Planning Commission Issues Report

Subject: Ordinance Amendment Issues Report

Meeting Date: February 24, 2014

Petition: P.Z. 14-2013 St. Luke's Hospital-West Campus (175 S. Woods Mill Rd.)

SECTION A-A
SCALE 1" = 40'

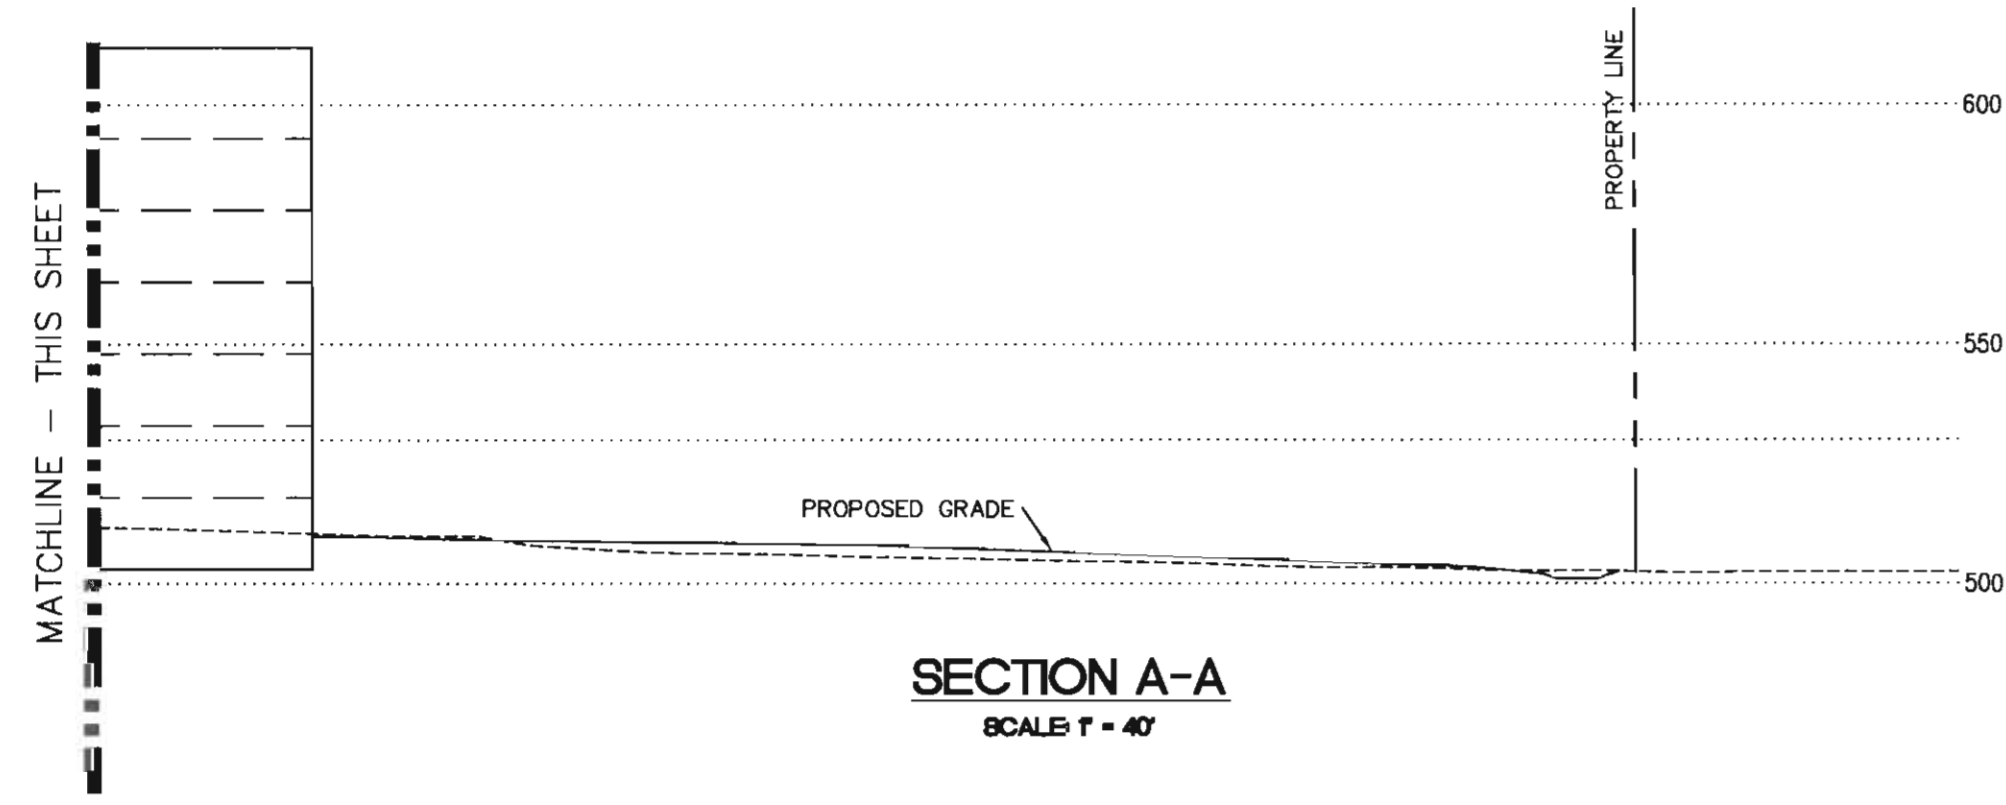
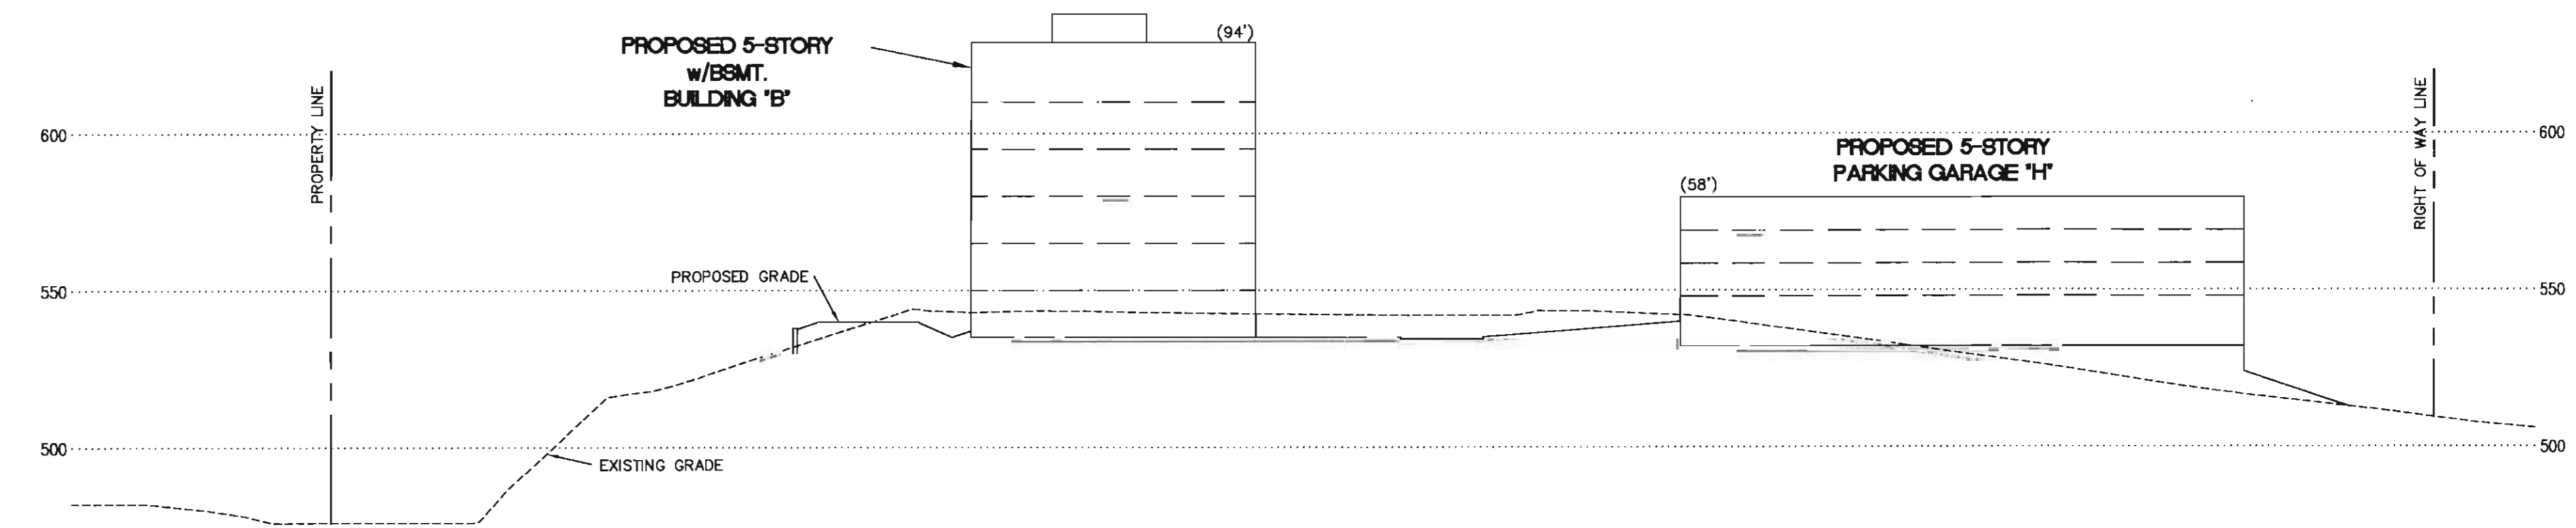
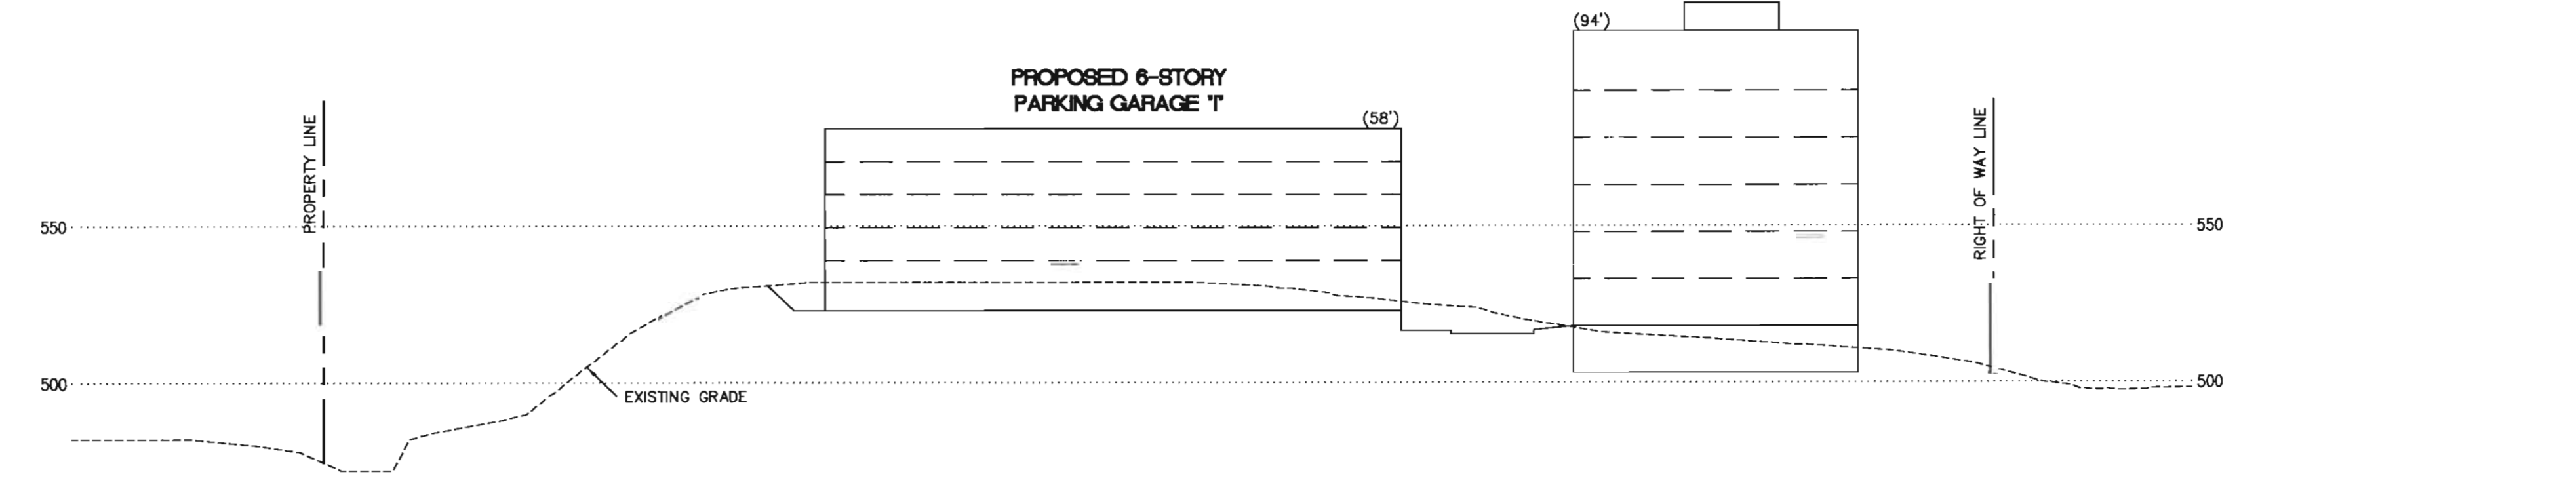
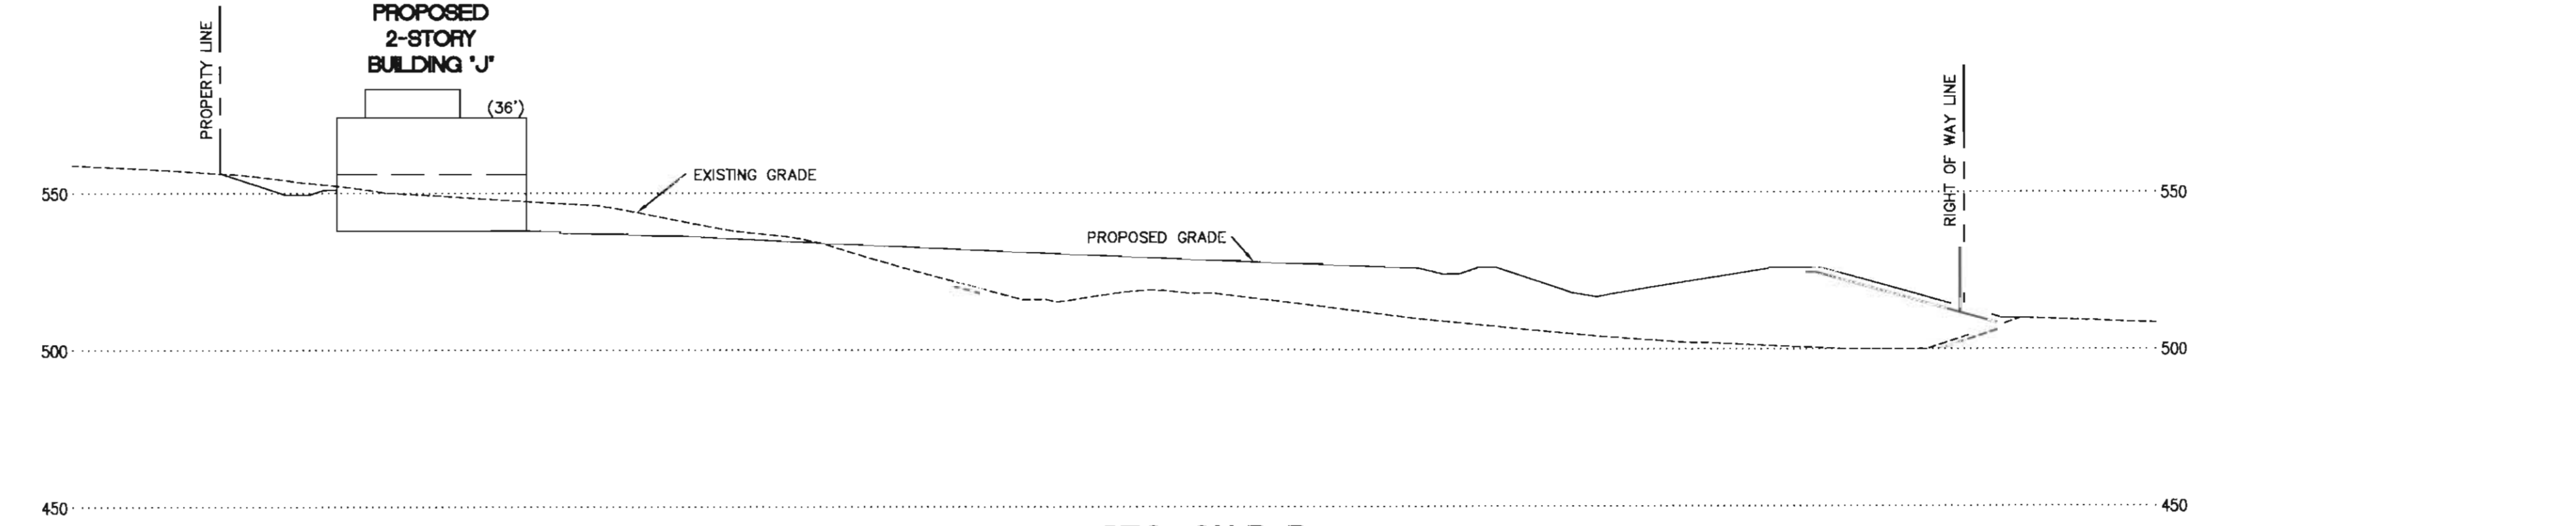
- **Questions were raised concerning the height of the proposed medical offices and parking garages.**

Discussion on staggering the height of these structures as one moves north through the site was deliberated. The idea was to mitigate the visual impact on adjoining uses (buildings become less tall as you move north). Due to the subject site being on a bluff, the structures may have a higher visual impact on adjoining properties, specifically from the west. Associated with this discussion, the Petitioner has provided a more detailed cut-sheet which depicts the height of all the proposed structures (feet and stories). An analysis of this information was provided above on page 5 of this report.

The height comparison is best viewed on Section A-A on page 5 of the Preliminary Plan. As proposed two medical buildings, Building "B" and "D", are listed at 94 feet in height along this bluff with a proposed parking structure, Building "I", listed at 58 feet north of the two medical buildings. While site topography loses elevation as you move north, the structures retain similar heights from grade. With this loss in elevation, the structures appear to lessen in height as you move north (see table 1 finished floor elevations). The Planning Commission may further evaluate the proposed issue and provide further direction to the Petitioner if necessary.

3. Questions were raised concerning the height of the proposed medical offices and parking garages. Staggering the height of these structures as you move north through the site was discussed to mitigate the visual impact on adjoining uses (buildings become less tall as you move north). Provide information.
The Revised Plan shows finished floor elevations that show the staggering of the height of these structures.
